## AMENDMENT NO. 13

## ONE HUNTERS POINT CONDOMINIUM

Located at:  
 5-49 Borden Avenue  
 Long Island City, Queens County, New York

Dated: February 26, 2008

DATE: 05/08/06  
SCALE: 1/8" = 1'-0"  
DRAWN BY: W. DESSALINES  
JOB #: 05-77  
DWG. #: UNIT 2A

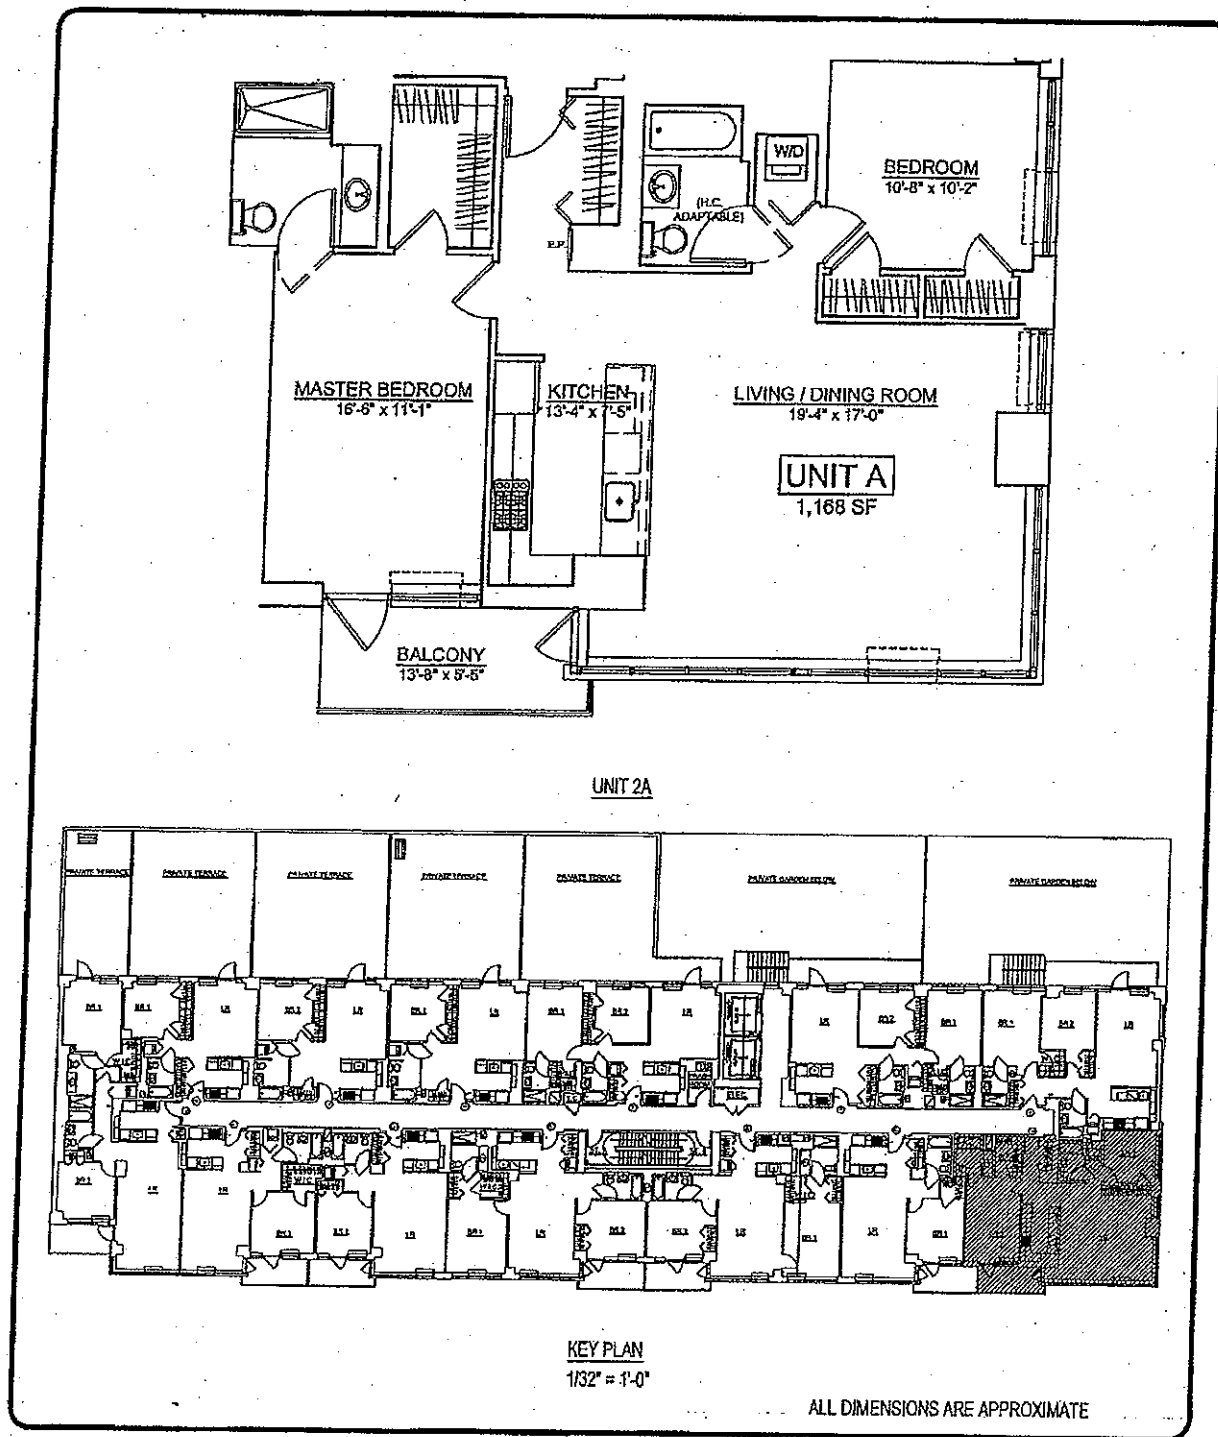
The diagrams for the Units designated below currently filed in the Offering Plan are hereby amended as reflected in Exhibit A annexed hereto. The subject units are:

These corrections were necessitated by (i) an overstatement of the square footage of the 2<sup>nd</sup> bedroom for Units designated as J-Residence, two bedrooms, floors 9 – 12, although the aggregate square footage of each such Unit has not changed, and (ii) a modification of the bathroom tubs to shower stalls in the master bedroom bathroom in all of the Units referenced above, except for Units 5D and 6D in which there has been a modification of the bathroom tubs to shower stalls in the second bedroom bathroom, and not the master bedroom bathroom.

DATE: 05/08/06  
SCALE: 1/8" = 2'-0"  
DRAWN BY: W. DESSALINES  
JOB #: 05-77  
DWG. #: UNIT 2F

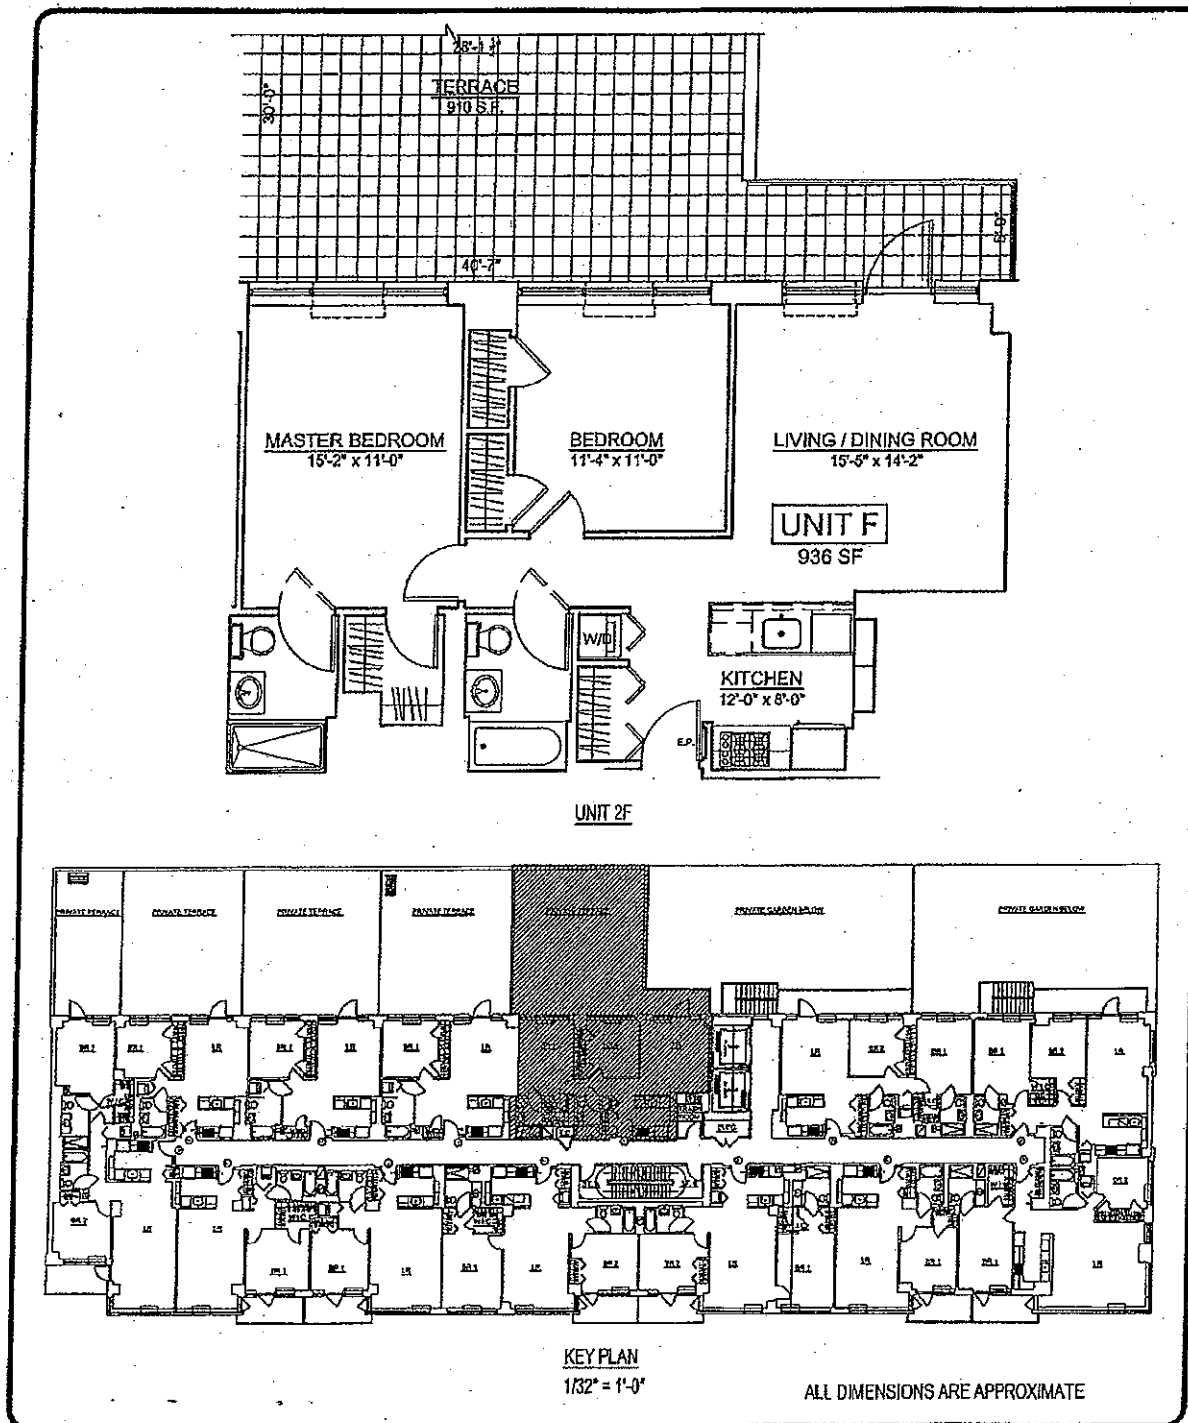
The exterior square footage as to certain Units have been changed as follows:

<u>Unit</u>	<u>Prior Exterior Sq. Footage</u>	<u>Revised Exterior Sq. Footage</u>
2F	1351	910
2N	1196	745
